Property Development (Project) Name (IF APPLICABLE): MIRAMONTE MIXED USE DEVELOPMENT

Re: DDO Application for Landscaping & Screening Substitutions
Miramonte Development Package, DP17-0169
3250 E. Speedway Boulevard | Tucson, AZ 85716

DESIGN DEVELOPMENT OPTION (DDO) APPLICATION For Landscaping/Screening Substitutions

responses to development permit landscape review comments

sd7.01

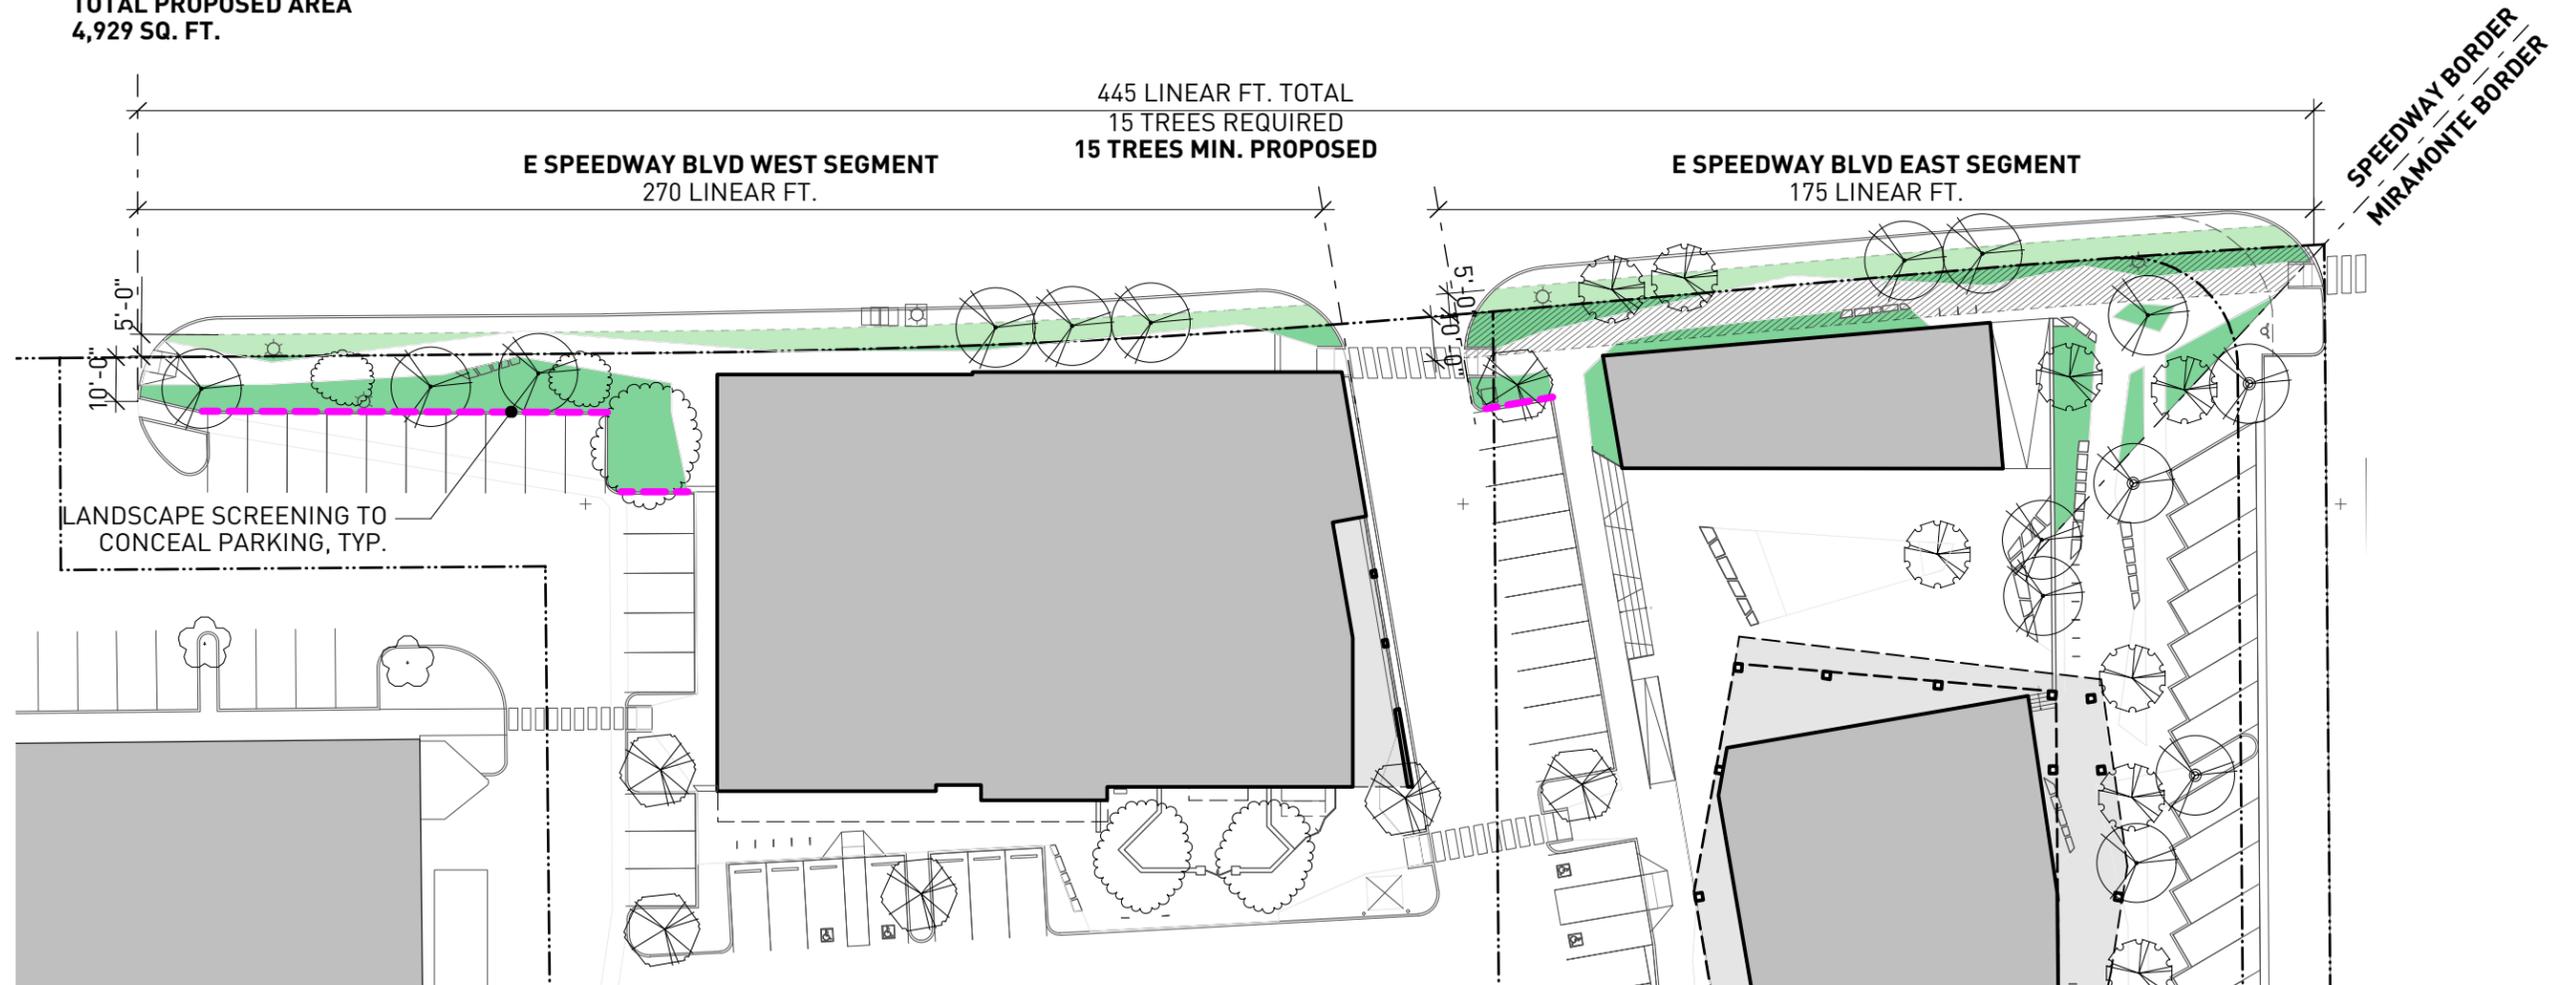
c) Portions of Landscape border along Speedway and 2nd Street are not 10' measured from street property line.

Portions of the required landscape buffer along Speedway are located entirely within the Public ROW.

Our design exceeds the street landscape border area requirement based on the equivalent area of this 10 ft. wide strip. However, since we are bringing the public right-of-way further into our site, we are redistributing the landscape border area in certain locations that go deeper than the 10 ft. strip, while allowing for the sidewalk to inhabit some of the area typically dedicated to the landscape border. See attached project description and supplemental diagrams for further justification.

We are only counting the portions that are within the 5 ft. wide strip over the property line for required landscaping along E. Speedway Blvd., where an existing building conflicts with the required depth of landscaping. Gary Wittwer at TDOT has already approved the inclusion of the 5 ft. wide strip within the public right-of-way. See attached correspondence. Please note that the MS&R current and future right of way lines are equal for the parcels in question.

-  REQUIRED AREA FOR LANDSCAPE BORDER
4,646 SQ. FT.
 -  PROPOSED STREET LANDSCAPE BORDER AREA
3,077 SQ. FT.
 -  PROPOSED STREET LANDSCAPE BORDER AREA WITHIN PUBLIC R.O.W.
1,852 SQ. FT.
- TOTAL PROPOSED AREA**
4,929 SQ. FT.

Sheet Number:
sd7.02

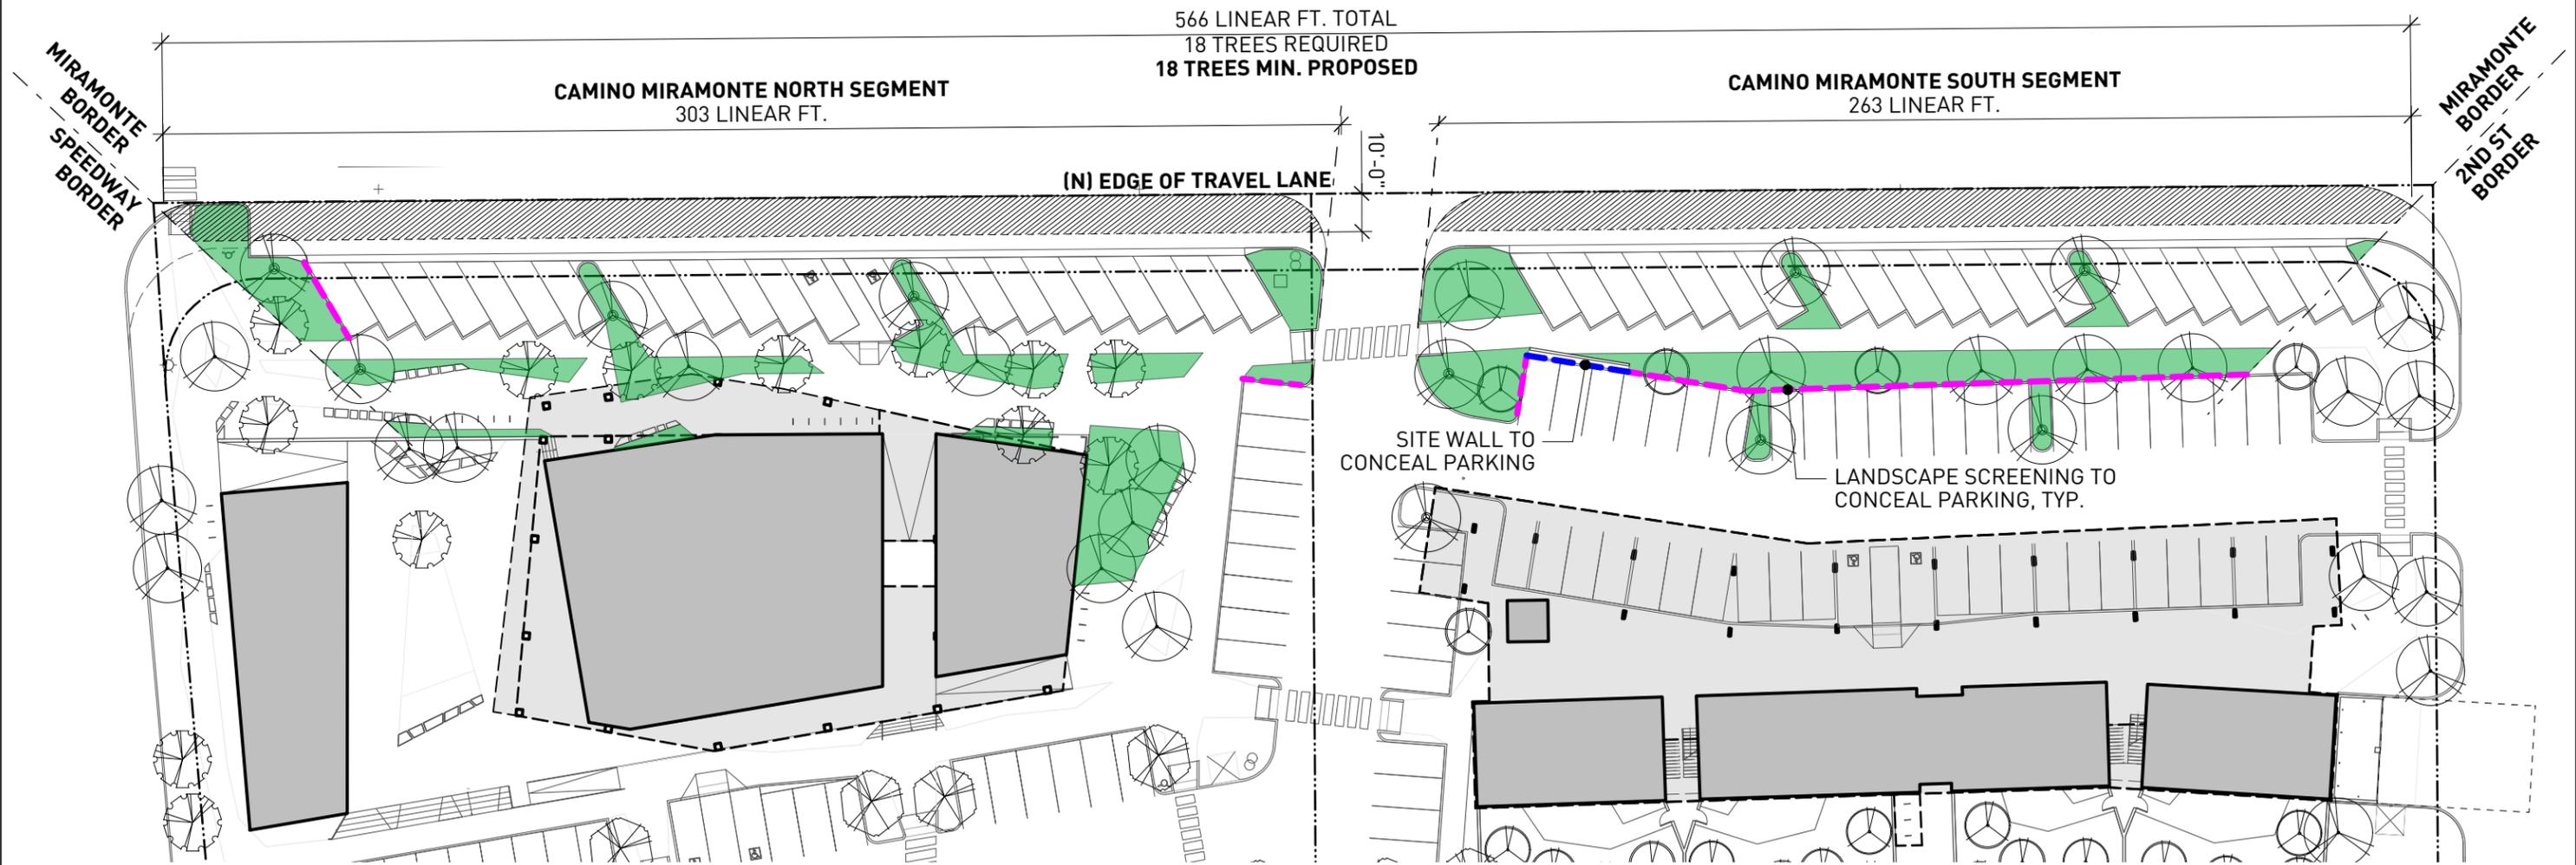
d) Large portion of the street landscape buffer along Camino Miramonte is not measured according to above criteria.

e) Parking spaces are located within required buffer area along Camino Miramonte

A 30" screen is required to screen vehicle use area from adjacent streets. No screening is indicated along Camino Miramonte for proposed parking.

relocation of the property line, resulting in the impossibility of locating the landscape border where the parking and maneuvering zone is located. We have calculated the area requirement based on the new property line, but propose to redistribute this area further into the site. See attached project description and supplemental diagrams for further justification.

Screening parking along Camino Miramonte that is directly accessed from that street would be impossible, so we request an exception for the parking at these locations.

-  REQUIRED AREA FOR LANDSCAPE BORDER
5,445 SQ. FT.
-  PROPOSED STREET LANDSCAPE BORDER AREA
6,247 SQ. FT.
- PROPOSED AREA**
6,247 SQ. FT.
